TOWNHOUSES BUILDING D

CLARENDON HILL PHASE TWO POAH

ZONING SUBMISSION 06/15/2026 REV 07/22/2026

ZONING DIMENSIONAL STANDARDS TABLE

Z-005

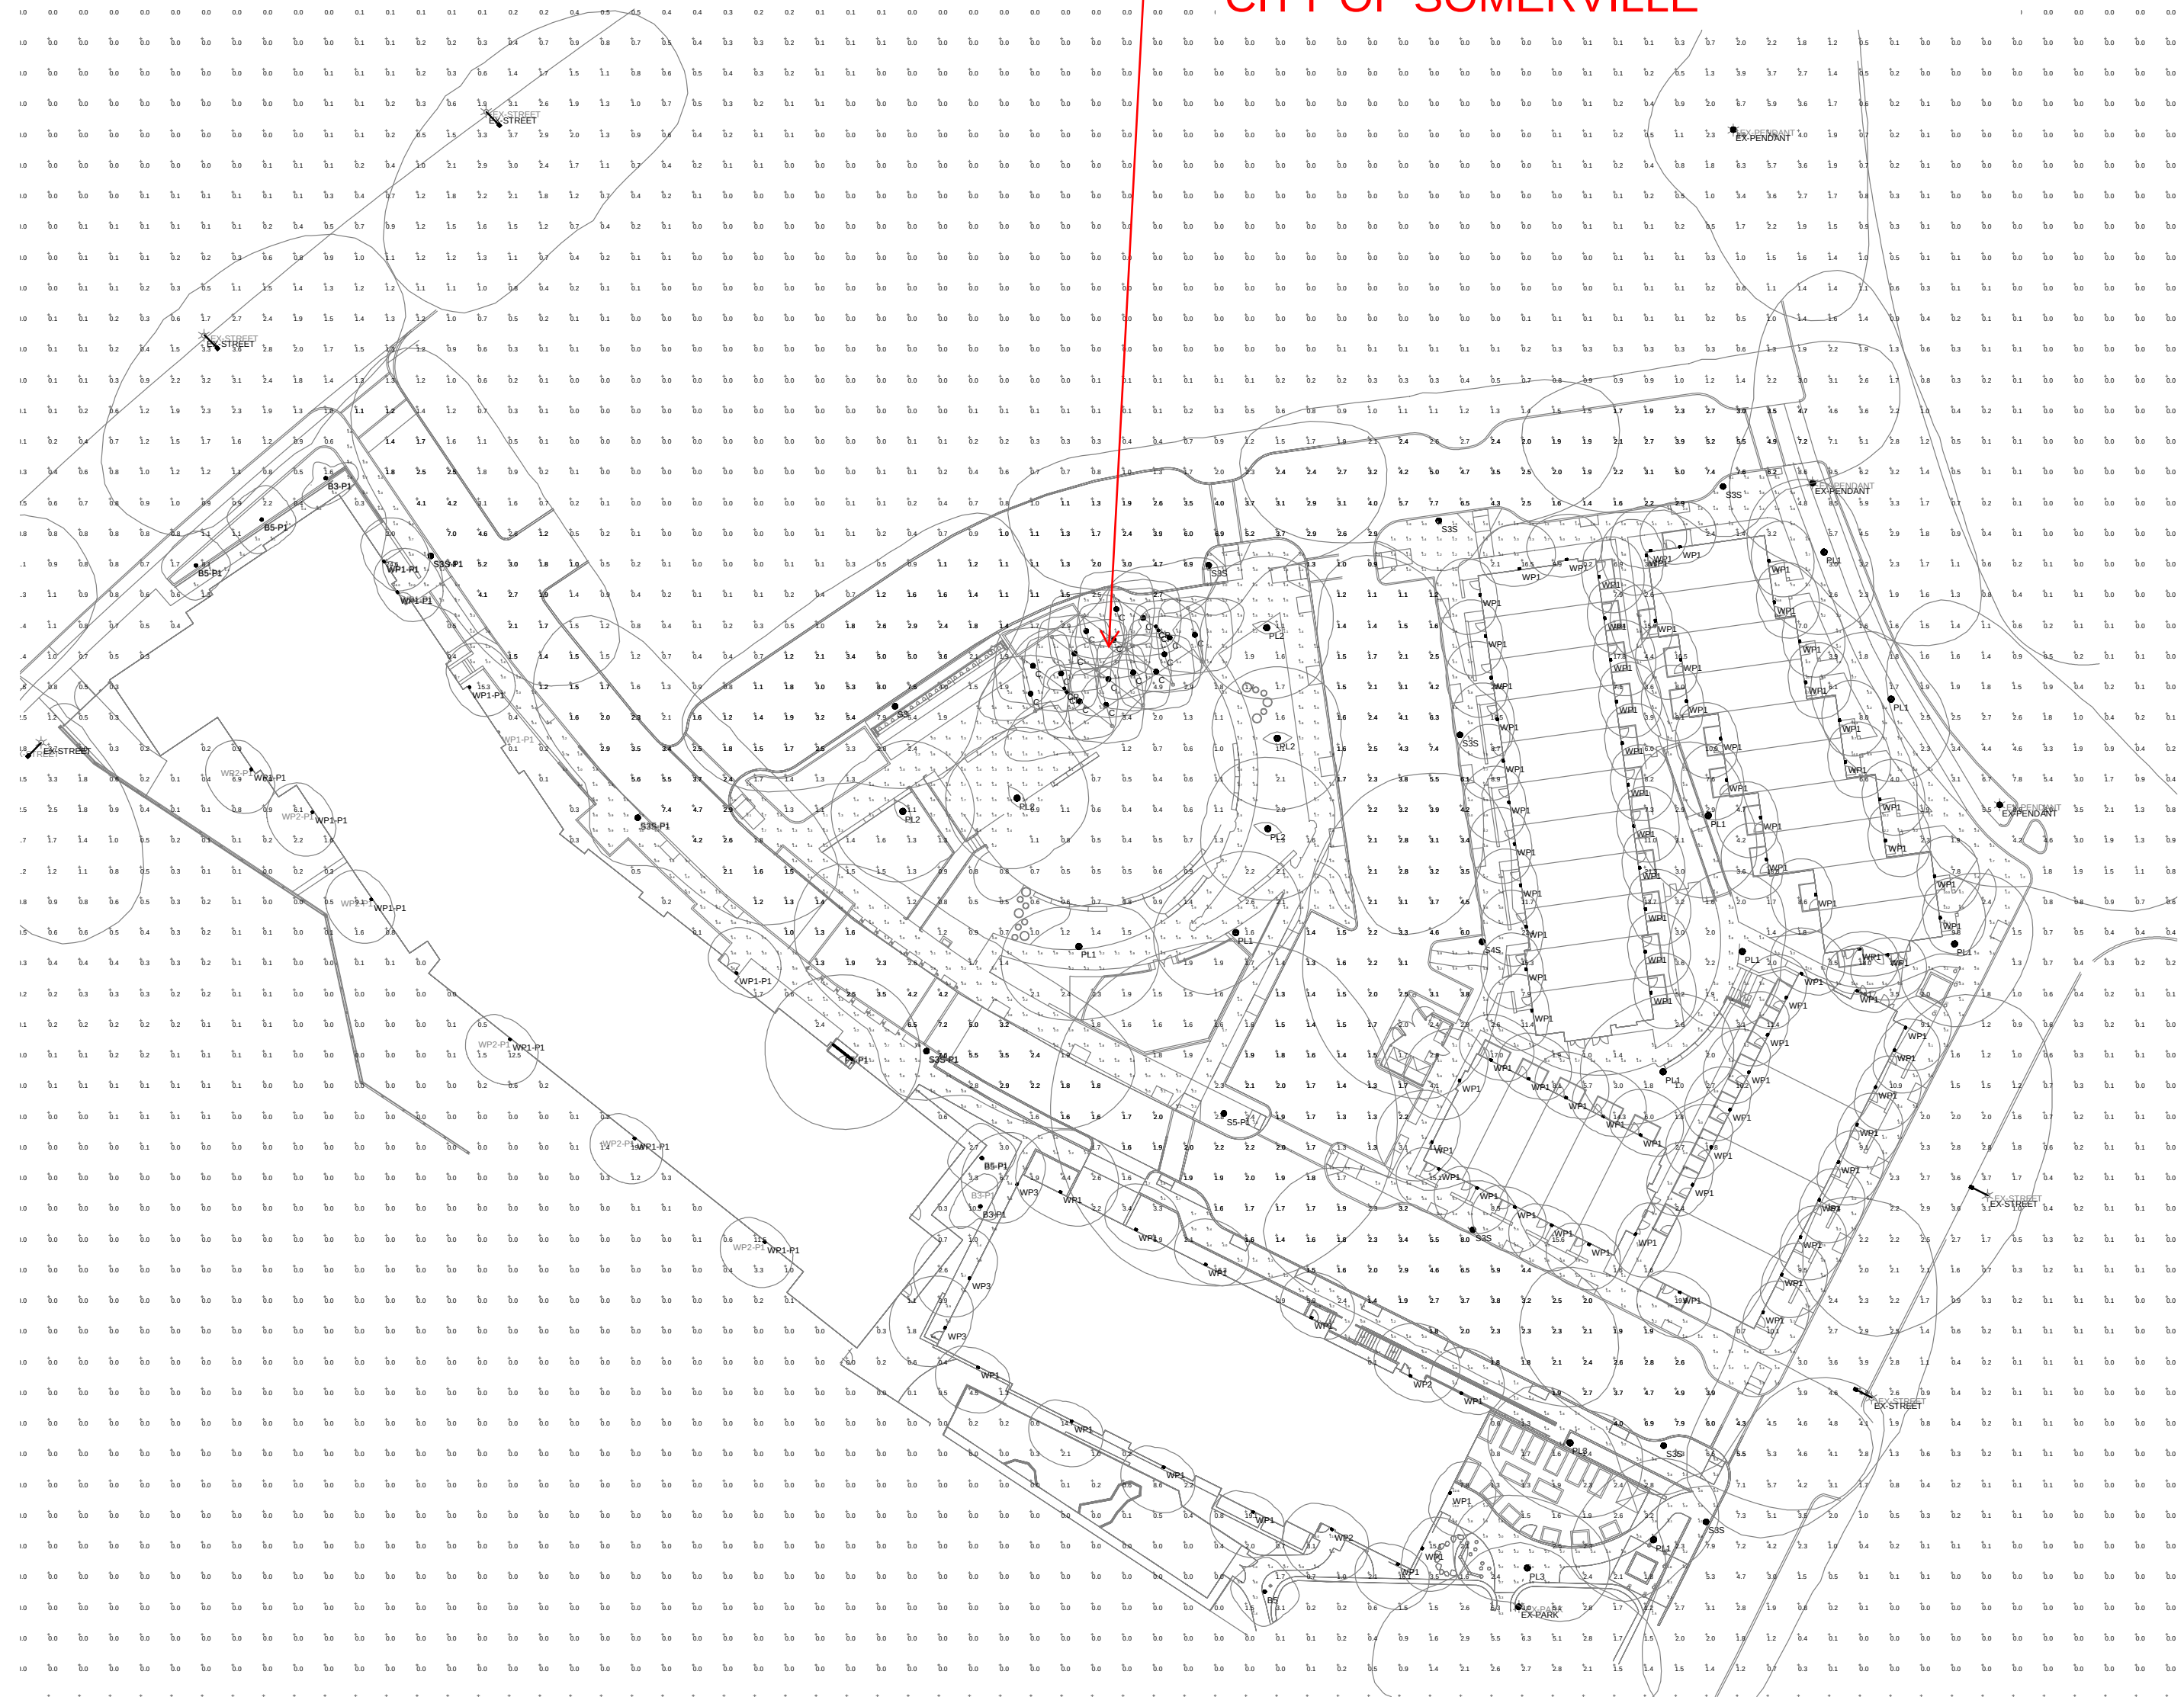
PROPOSED JUNE 15, 2026:
PHASE 2 PHOTOMETRIC PLAN
